RE: AFC Supplement C
Cosumnes Power Plant (01-AFC-19)

COSUMNES POWER PLANT (01-AFC-19)

AFC SUPPLEMENT C (Zero-liquid Discharge Arrangement)

Submitted by
**SACRAMENTO MUNICIPAL
UTILITY DISTRICT (SMUD)**

FIGURE 1.1-3R2
SITE PLAN
COSUMNES POWER PLANT

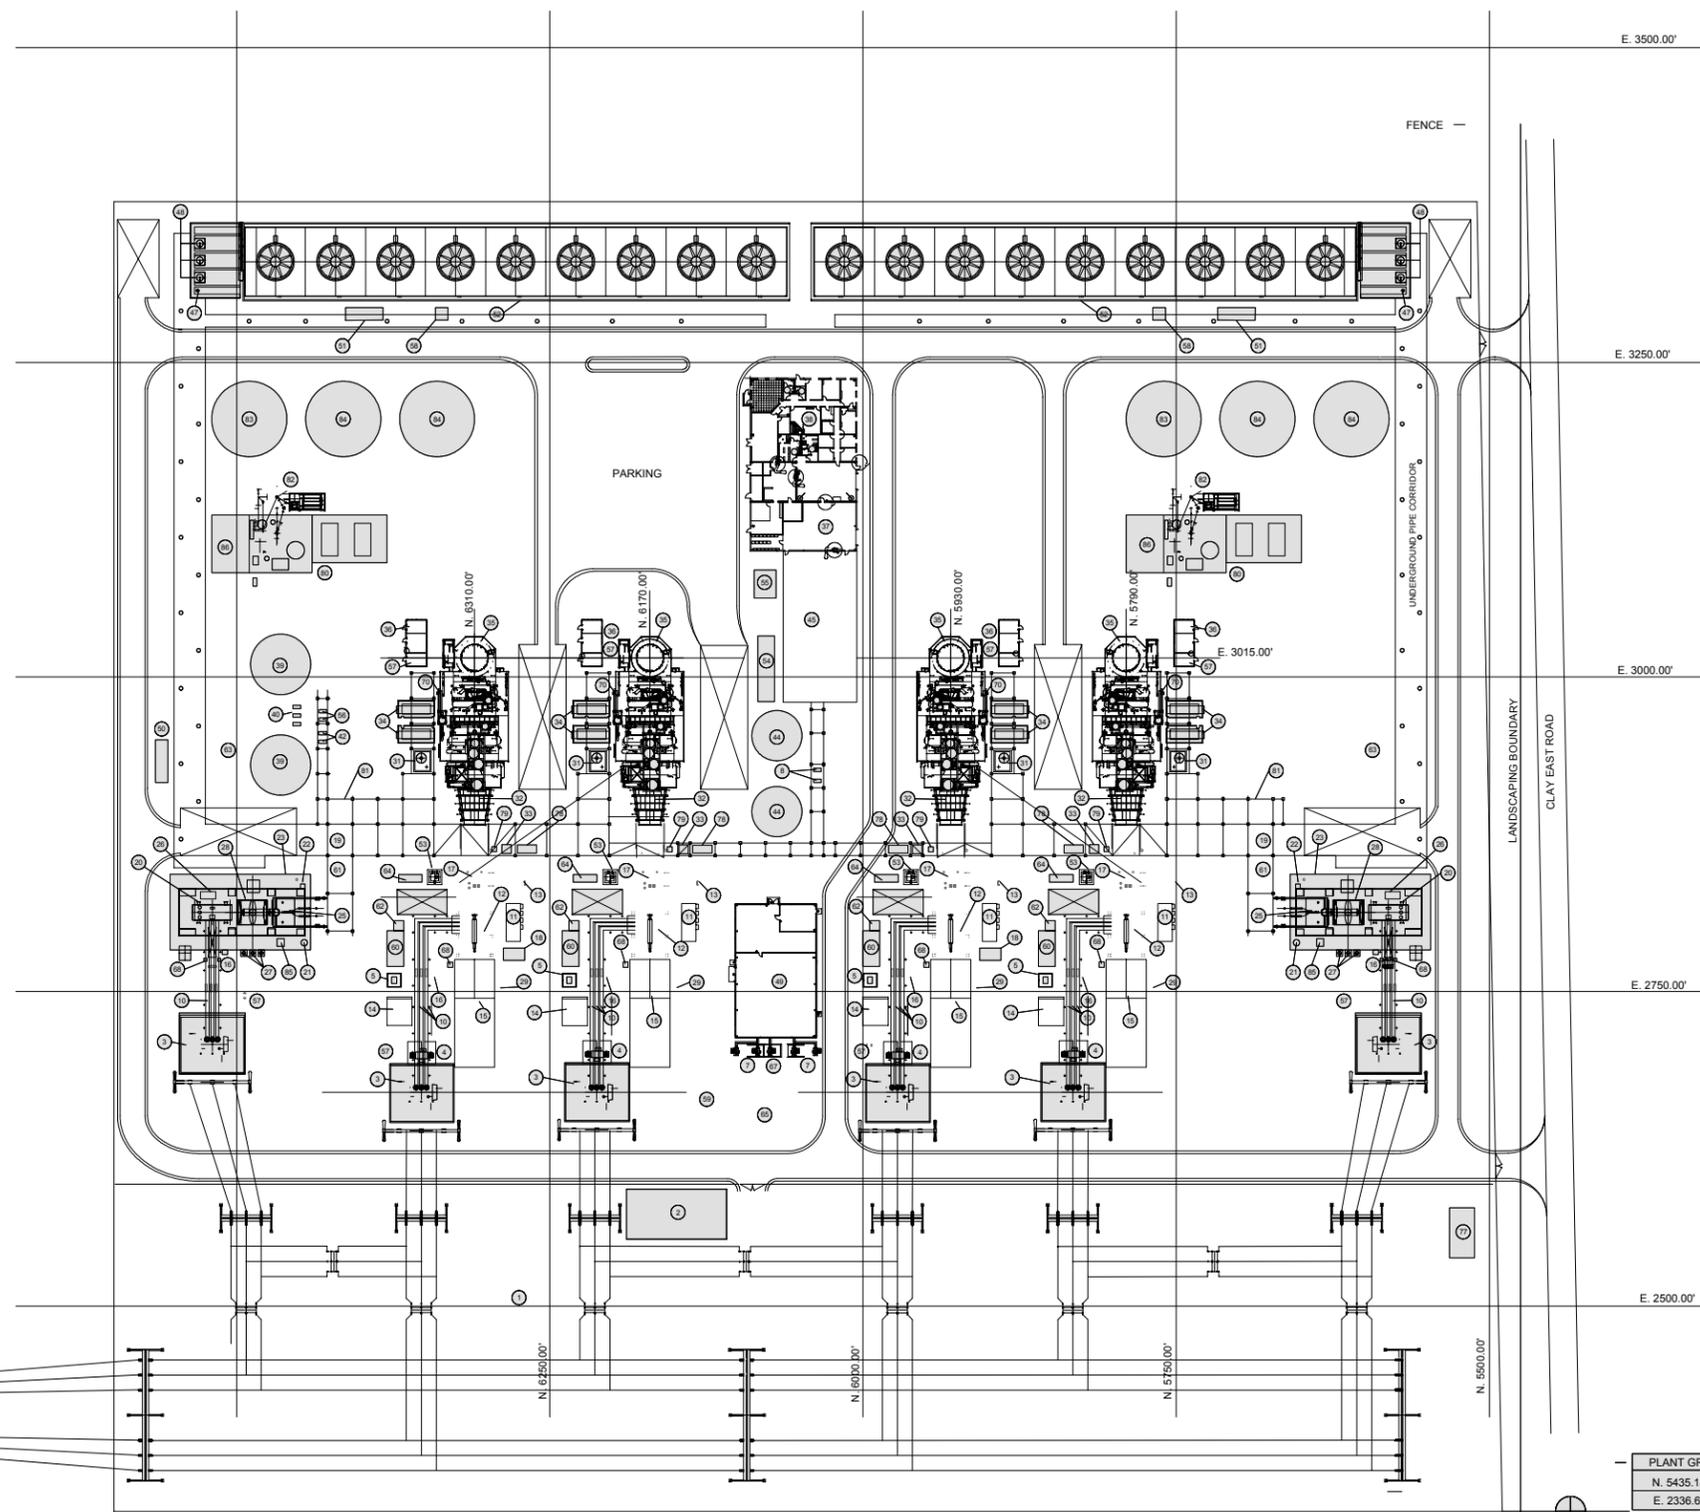
A new site plan showing the proposed change is presented in Figures 1.1-3R2 and 2.2-1R2. In addition, a new elevation is provided as Figure 2.2-2R2. The artist rendering submitted in the AFC as Figure 1.1-5, has also been revised to reflect these changes and is provided as Figure 1.1-5R. These figures replace those previously submitted in the AFC.

FIGURE 2.2-2 R2
SITE ELEVATION
COSUMNES POWER PLANT
 COSUMNES POWER PLANT

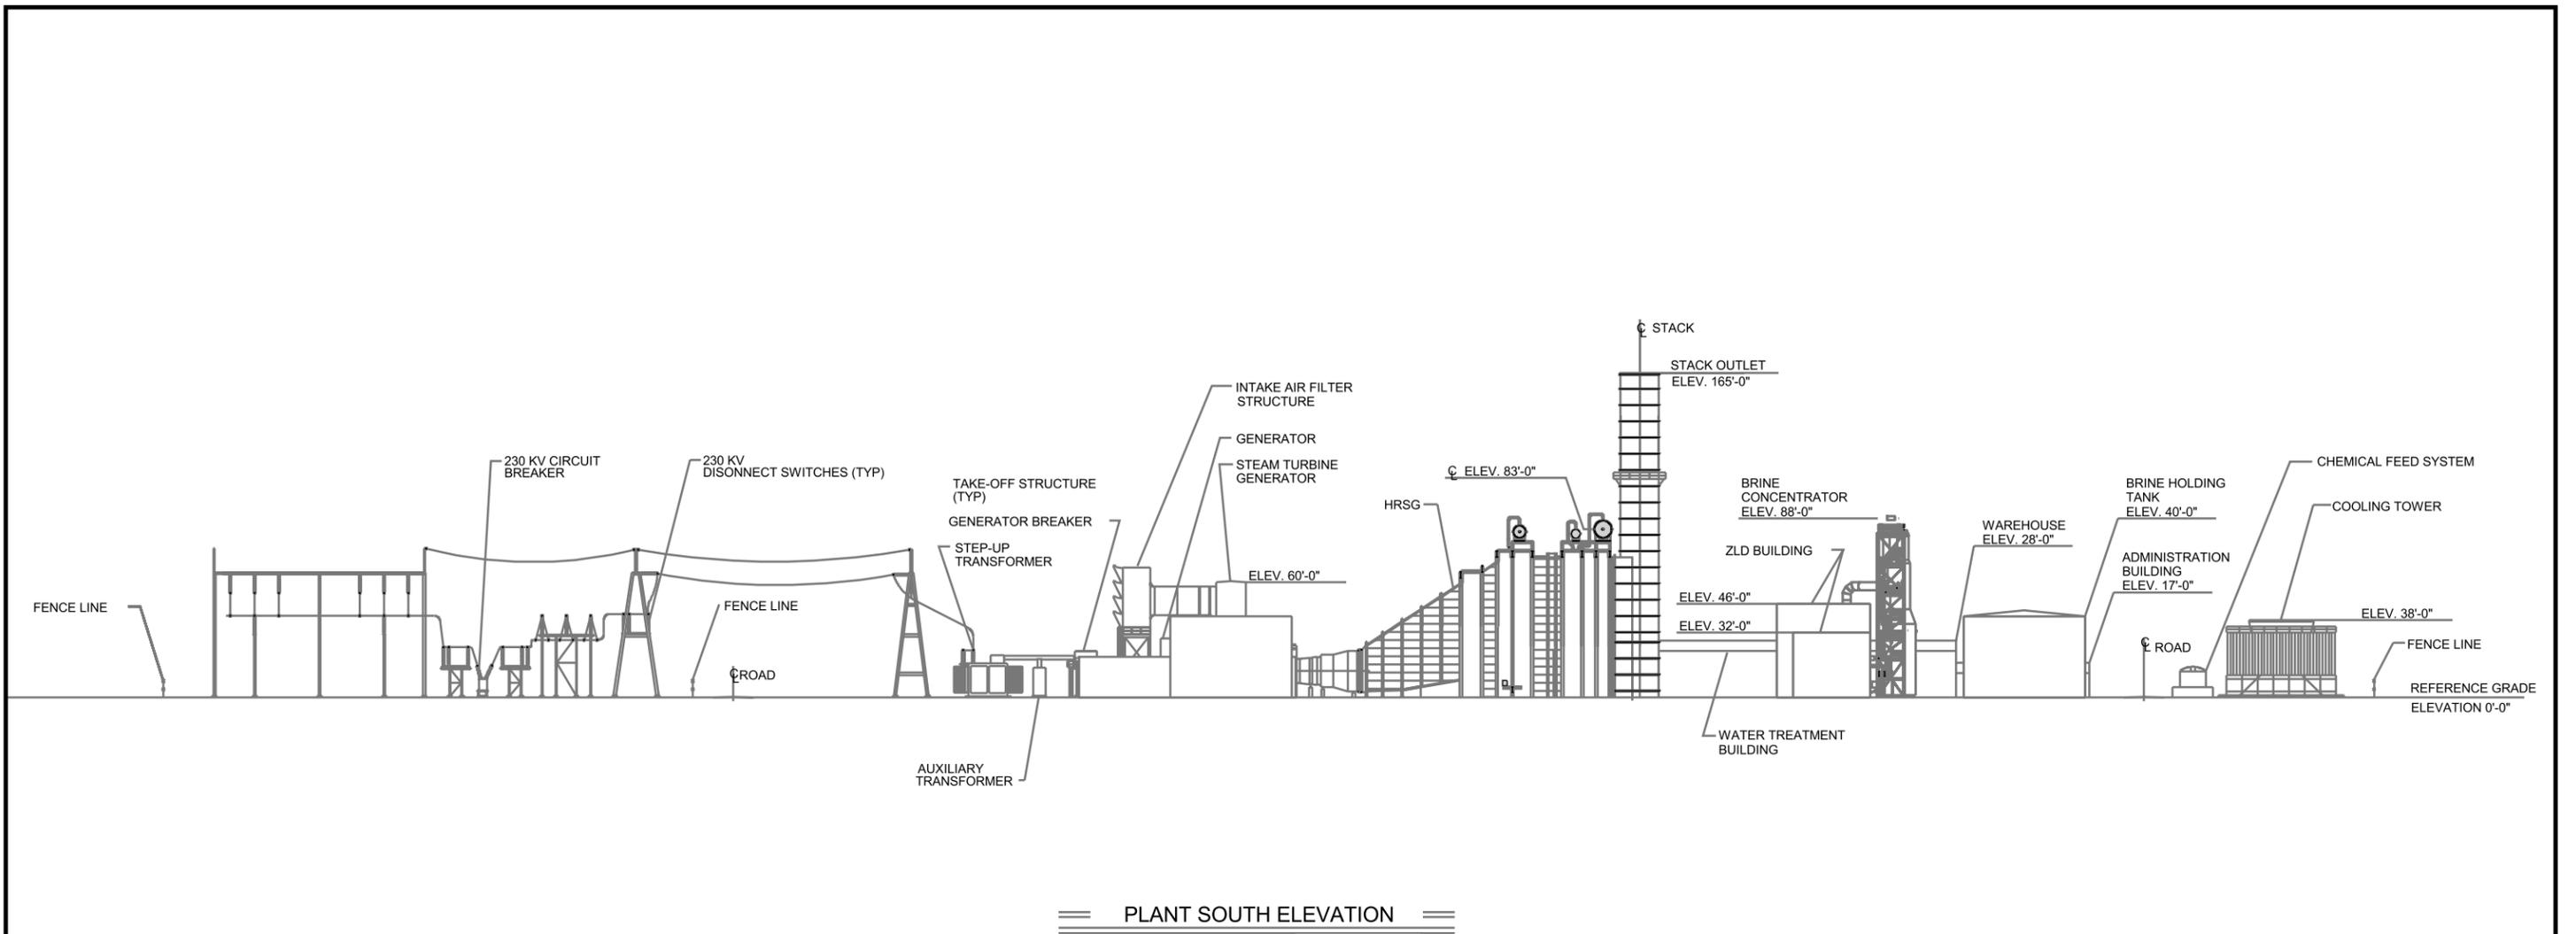
Visual Resources – The brine concentrator will add an 88-foot tall structure to the plant. However, it will only be half the height of the HRSG exhaust stacks. Although visual impacts will remain adverse, they are not considered significant.

FIGURE 2.2-7
ZLD PROCESS FLOW DIAGRAM
 RANCHO SECO SWITCHYARD
CH2MHILL

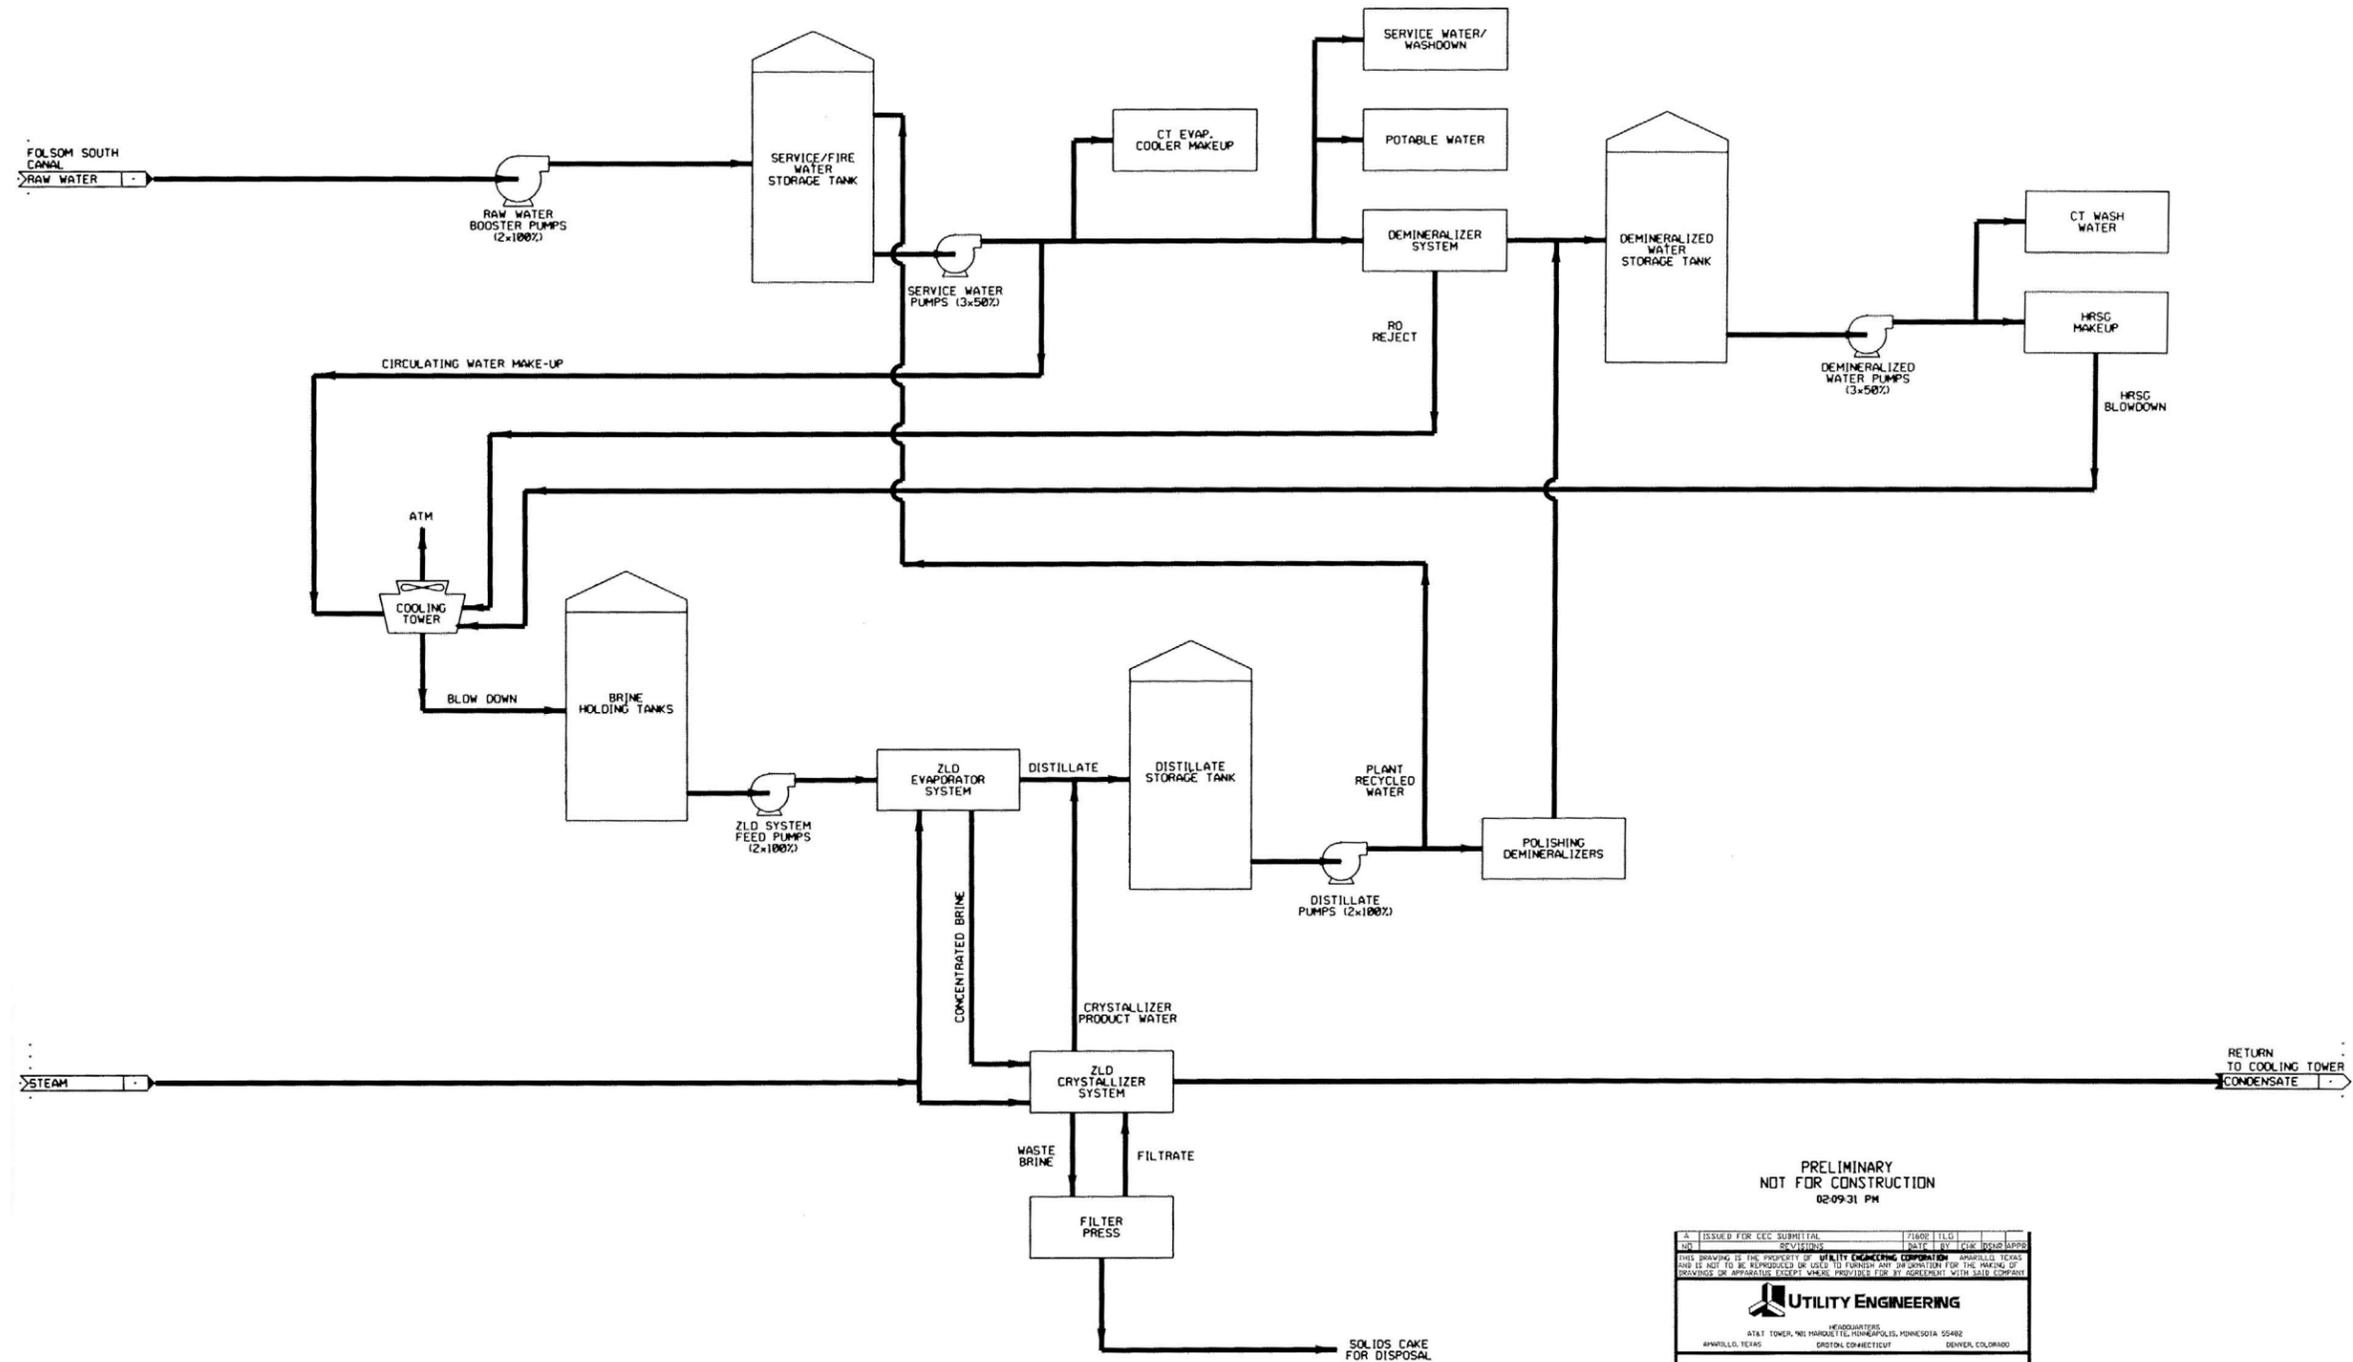
The ZLD system for the SMUD Cosumnes Power Plant will be designed to process all of the wastewater produced by the plant, returning a relatively high quality distillate stream for reuse in the plant and producing a solids waste stream suitable for disposal in a landfill. Wastewater streams to be processed include the cooling tower blowdown, filter backwash, reverse osmosis reject, HRSG blowdown, and miscellaneous plant wastewater. A process flow diagram is provided as Figure 2.2-7 (figures are at the end of the sections in numeric order). This is a conceptual drawing and will be revised in final engineering. (The water balance diagrams are more detailed and take precedence over the process flow diagram.)

The ZLD system will be designed to treat a maximum of 200 gpm wastewater, and will have the capability of operating down to approximately 50 percent capacity. Wastewater will be processed in two steps; the first will be a brine concentrator, which will concentrate the wastewater to approximately a 15 percent salt concentration and produce a clean distillate stream. The second step will further process the remaining wastewater, producing a clean distillate stream and a waste solids stream, and will likely consist of a crystallizer system.

FIGURE 8.5-2R2
Proposed Consumnes Power Plant
Expected Plant Noise Emission Contours
During Normal Base Load Operation

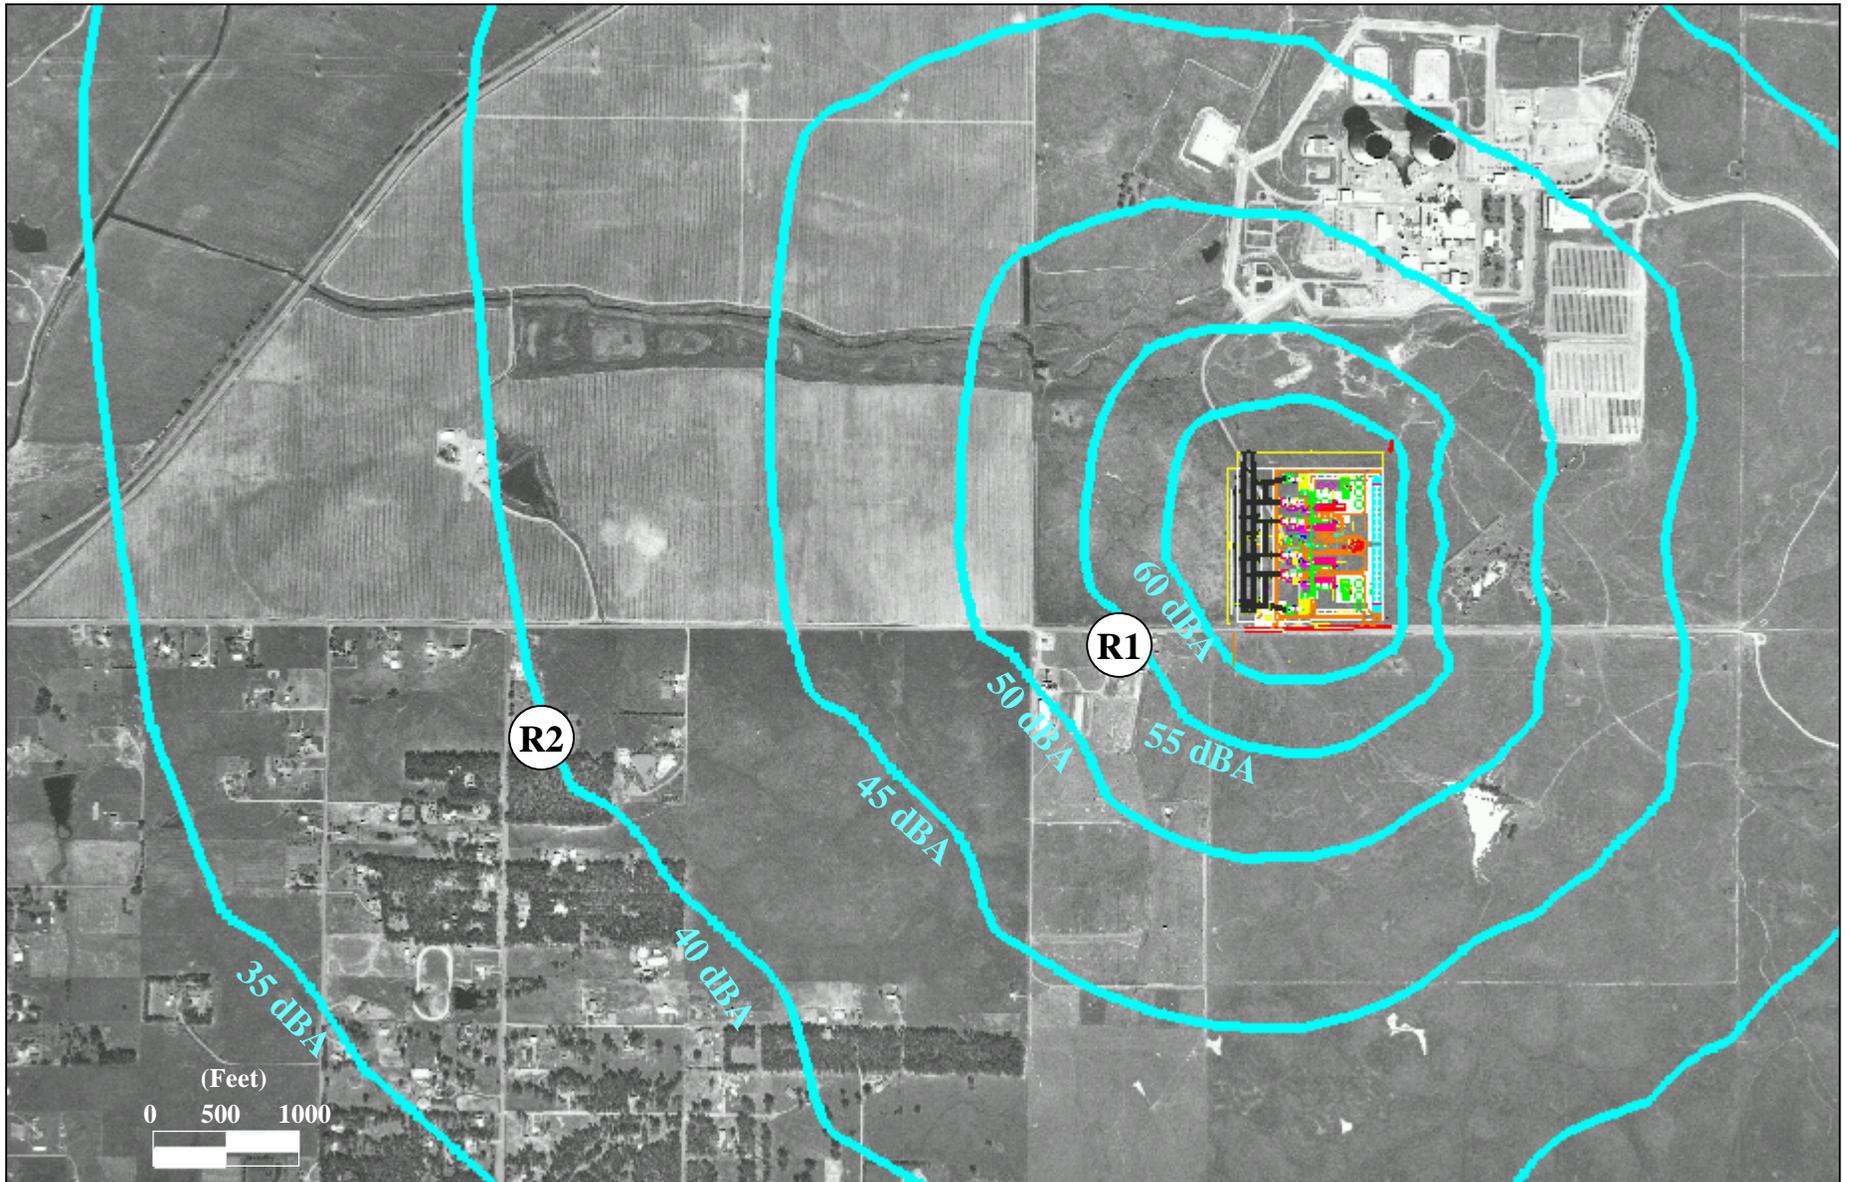
The noise modeling performed in the AFC was rerun to determine if the addition of the ZLD equipment would adversely affect the noise contours provided in Supplement A to AFC. The modeling results indicated that the ZLD addition would result in a very slight increase (on the order of 0.5 dBA) in overall plant noise levels. However, it was noted at the June 11, 2002, workshop that the STG condensers were the noisiest pieces of equipment at the plant site. Therefore, additional noise control measures were added to the plant.

Modeling was run assuming the placement of barrier walls/cladding on the west and south sides of the steam turbine condenser areas, combined with moderate (achieving a minimum of 5 dBA noise reduction) HRSG stack silencers. The modeling indicated that the noise reduction from the condenser areas in the direction of the noise-sensitive receivers was 8 to 10 dBA. Consequently, the implementation of these additional measures would both offset the ZLD addition and result in a further decrease of overall plant noise levels. Based on the

modeling results, noise levels at R2 are predicted to be 40 dBA. Noise contours showing the modeling results are provided as Figure 8.5-2R2. The modeling data is presented as Exhibit NO-1.
